## Amendments to the 2002 Water System Standards

# BOARD OF WATER SUPPLY

SUBJECT: WATER SYSTEM STANDARDS AMENDMENTS

DIVISION 400 – APPROVED MATERIALS LIST AND STANDARD DETAILS, Section  
403 – Standard Details:

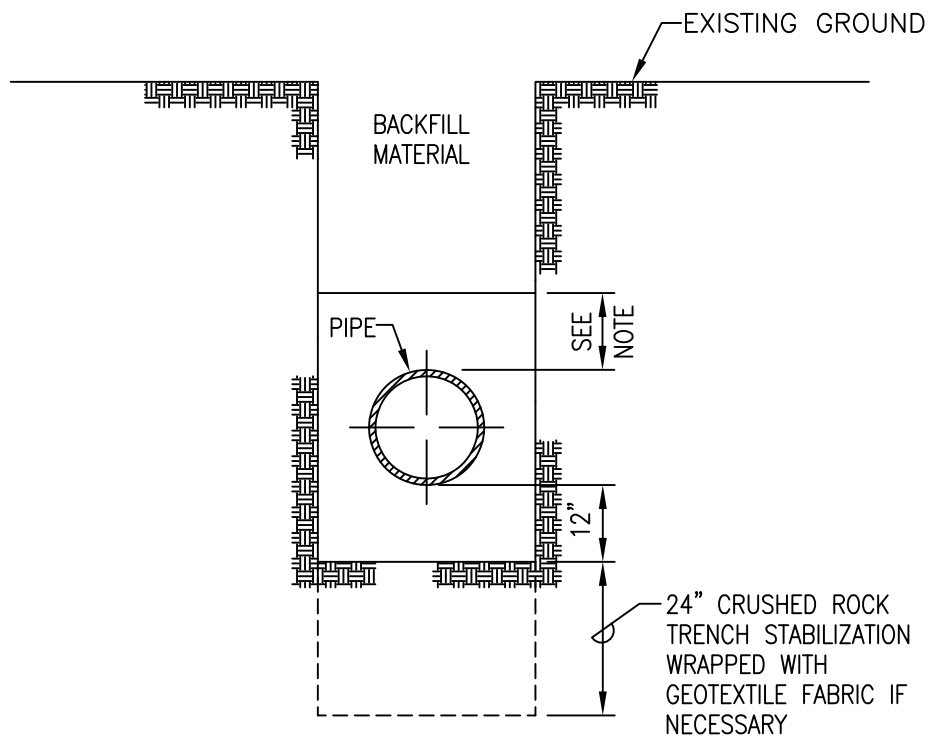
1. Delete Standard Detail P10 TRENCH BACKFILL and replace with the enclosed Standard Detail P10 TRENCH BACKFILL (2016 Revision) which reflects the increase in cushion material below the pipe to 12 inches.

8" X 2" FM METER & BOX LAYOUT FIRE AND DOMESTIC USES - CMU WALLS  
 SCALE: NTS

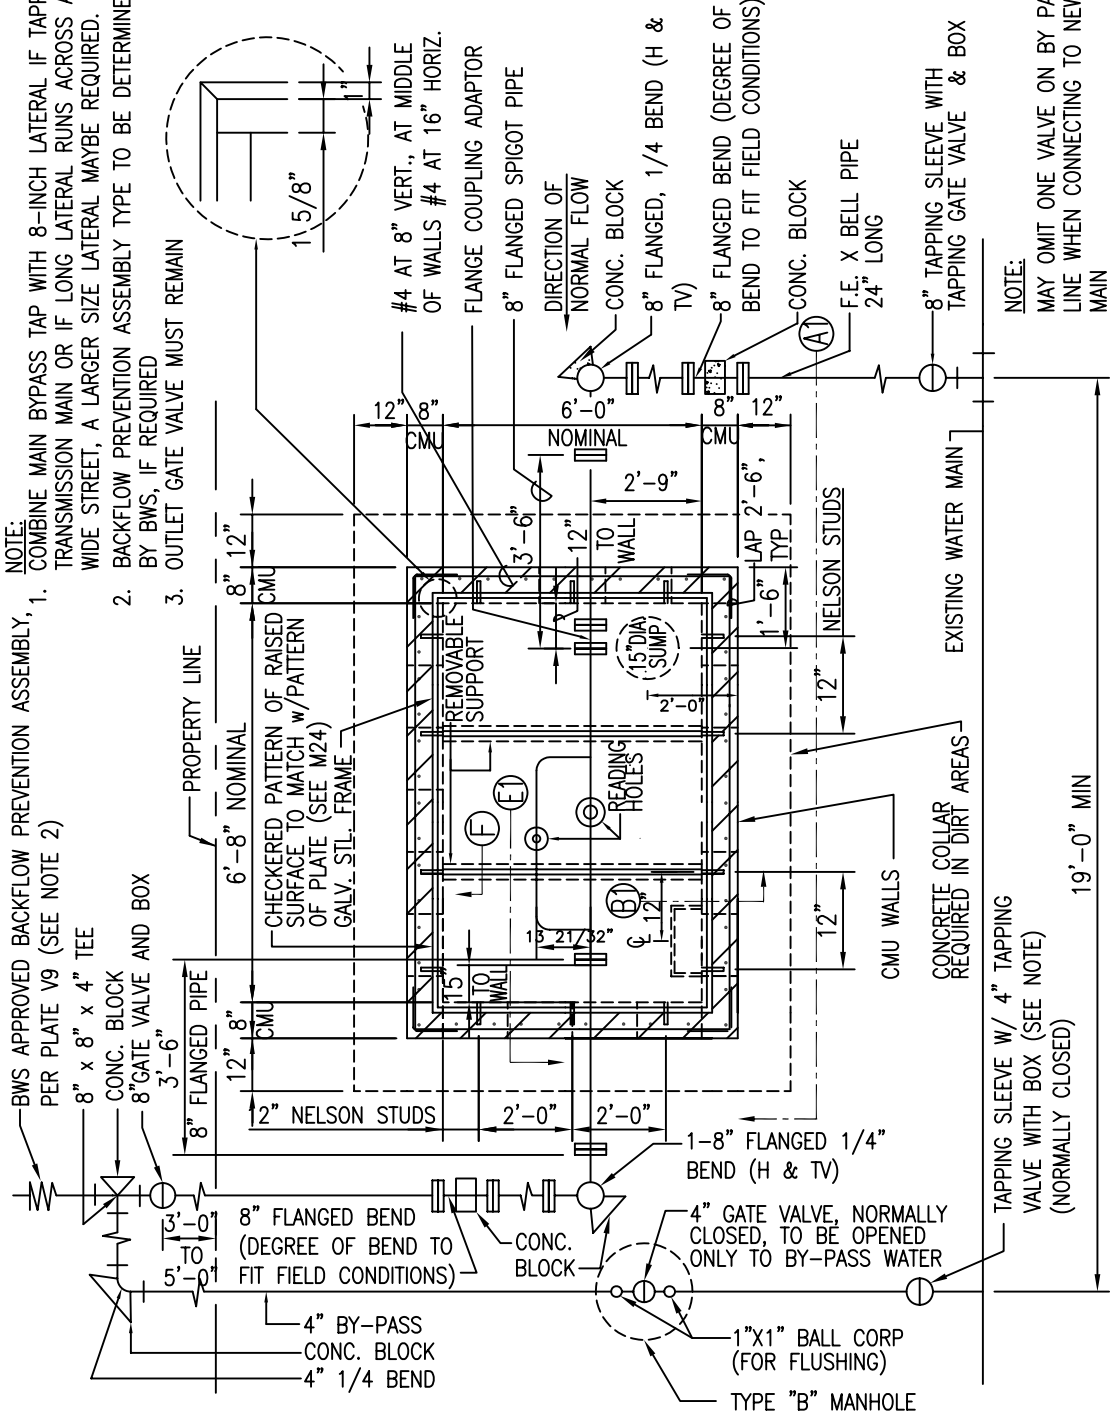
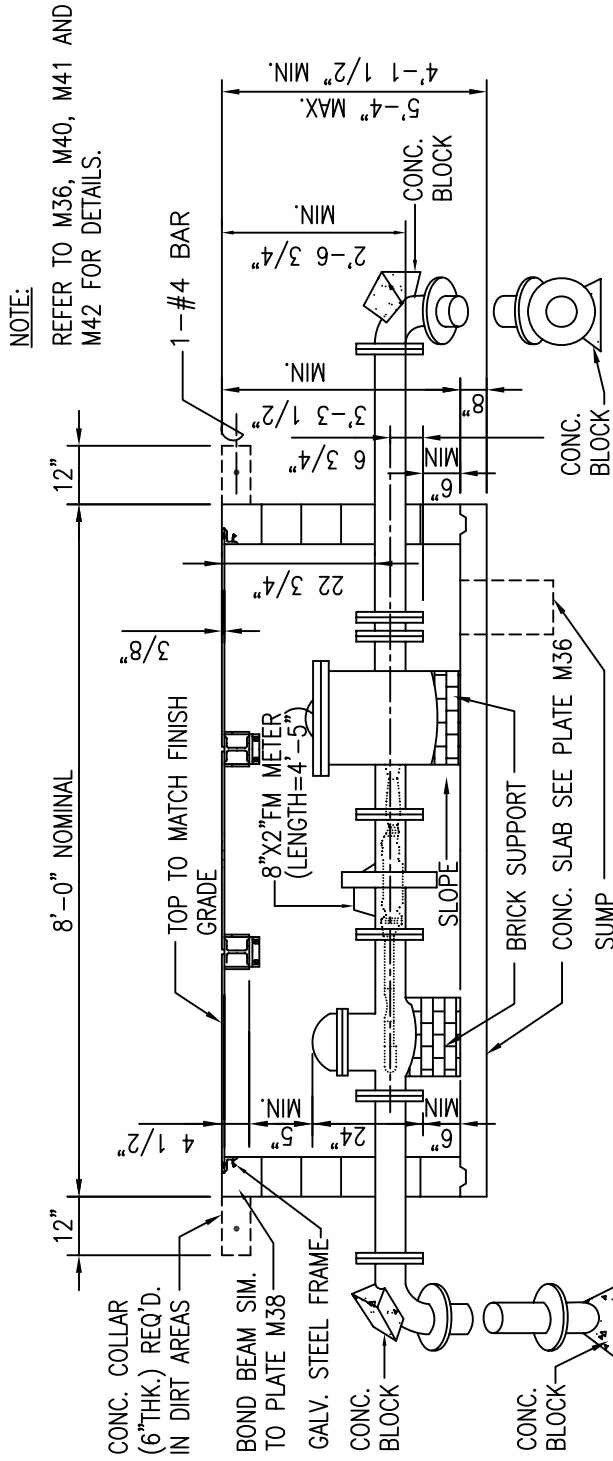
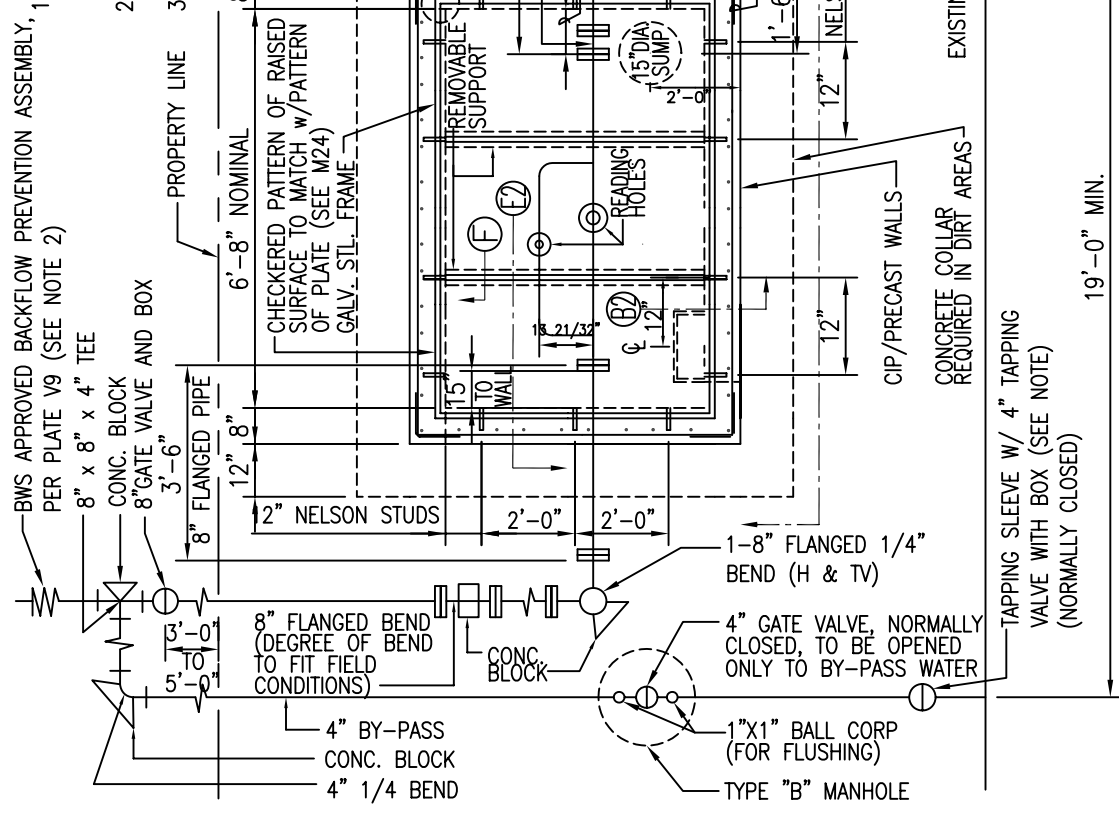
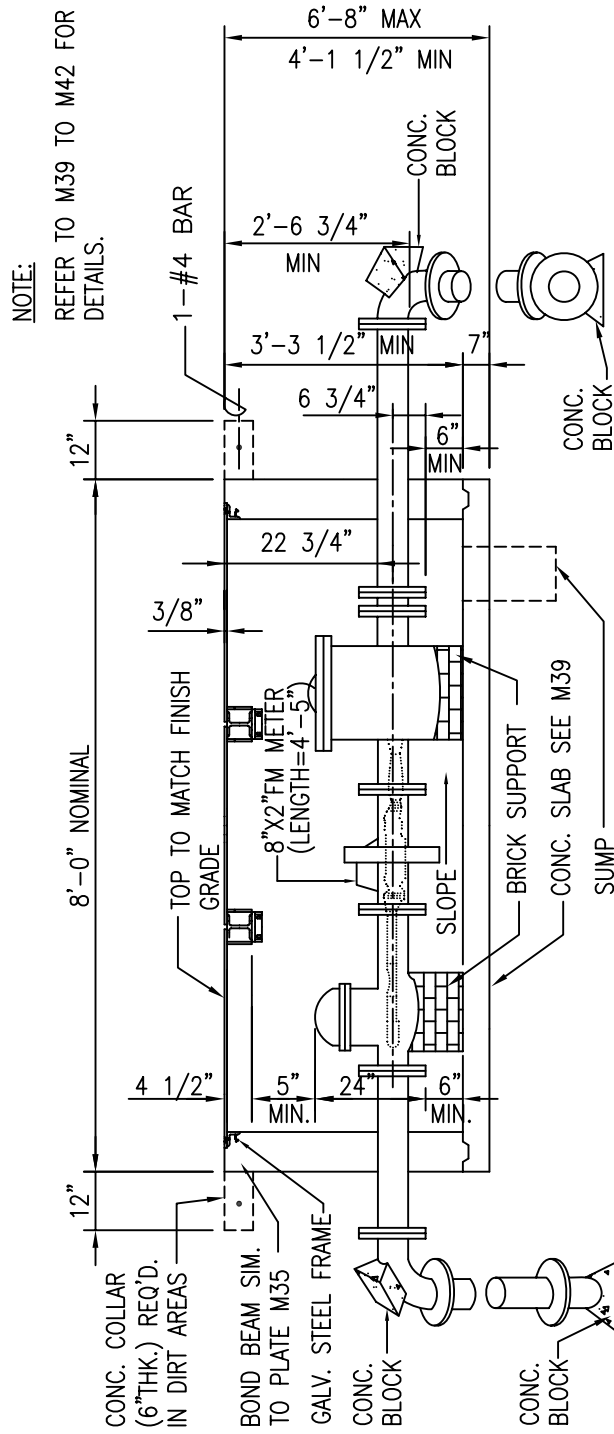
Replace the following details with the enclosed details (2009 Revision):

The manhole rungs in the FM meter box have been relocated to the outlet side of the meter to improve access for maintenance by Board of Water Supply personnel. The sump will be located on the opposite side due to the relocation of the manhole rungs.

COPPER SERVICE LATERAL  
FOR CONNECTION TYPE "X" METER BOX  
5/8", 3/4", & 1" METERS  
SCALE: NTS

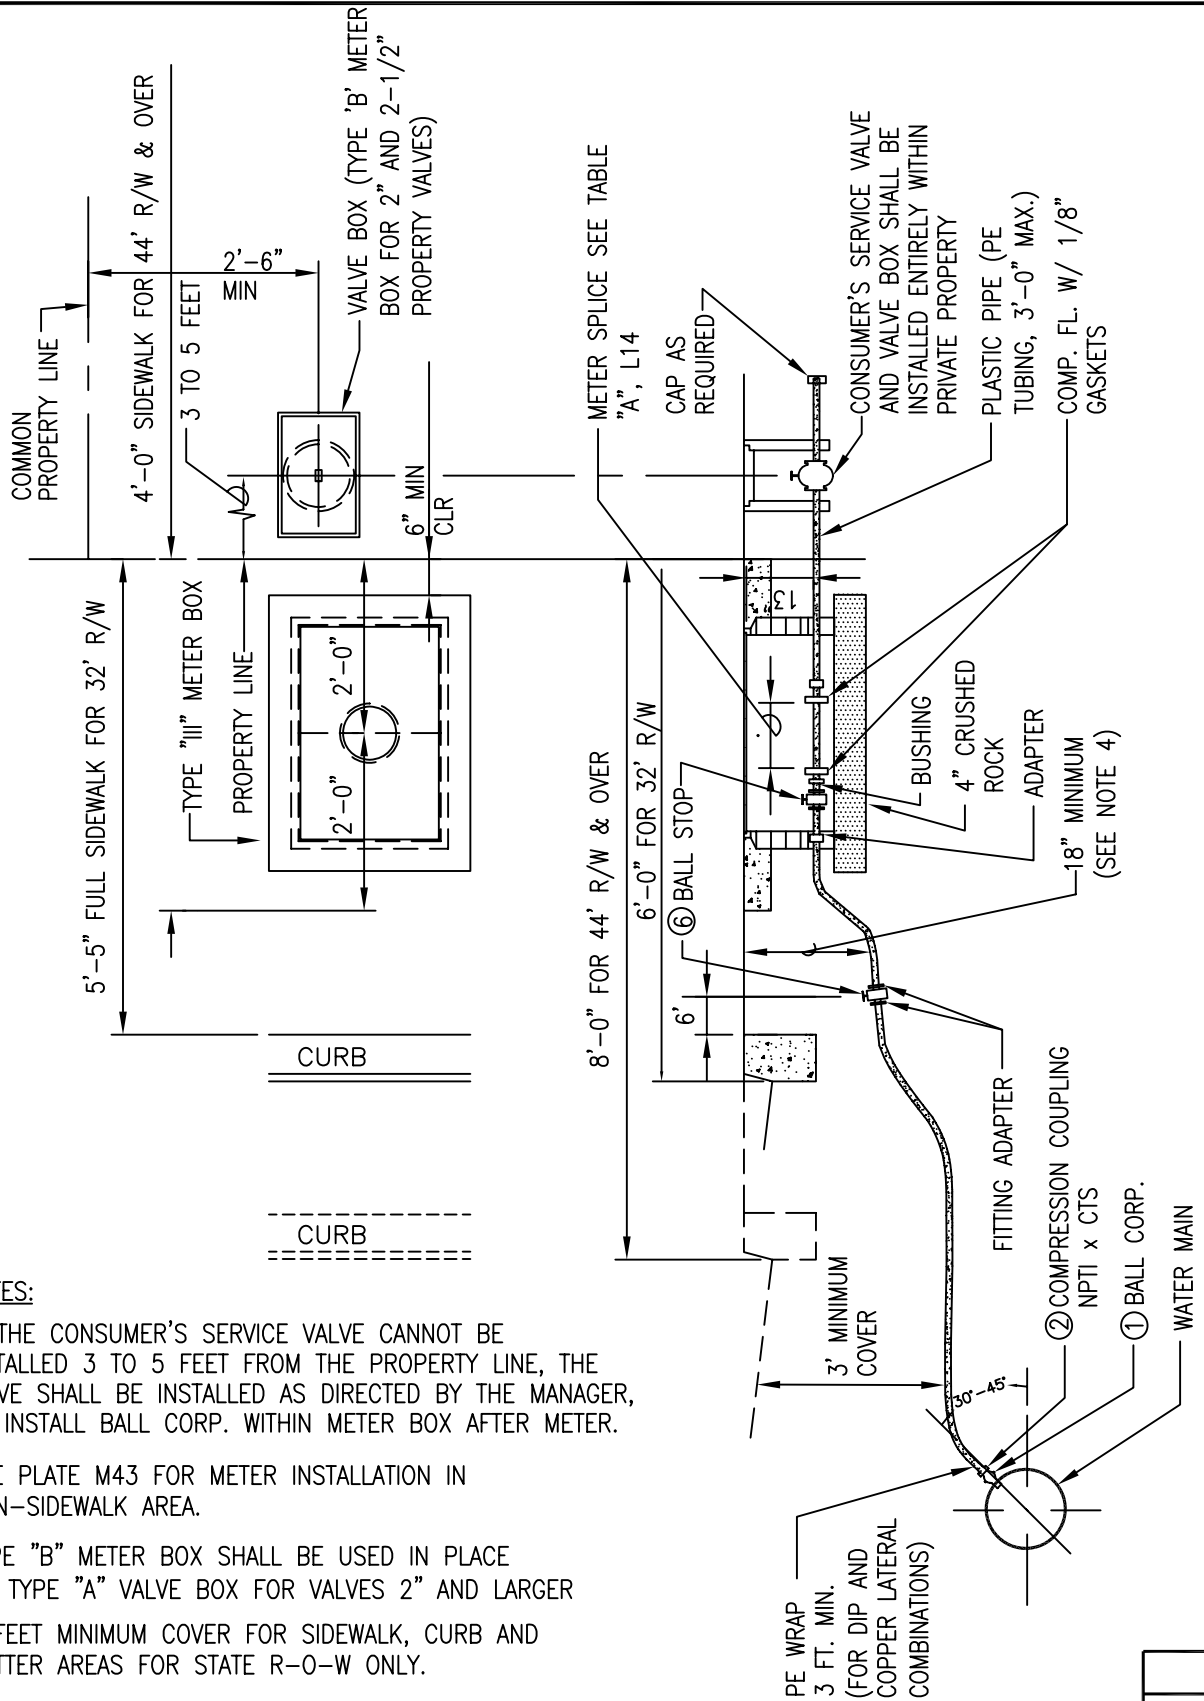
Replace the following details with the enclosed details (2008 Revision):
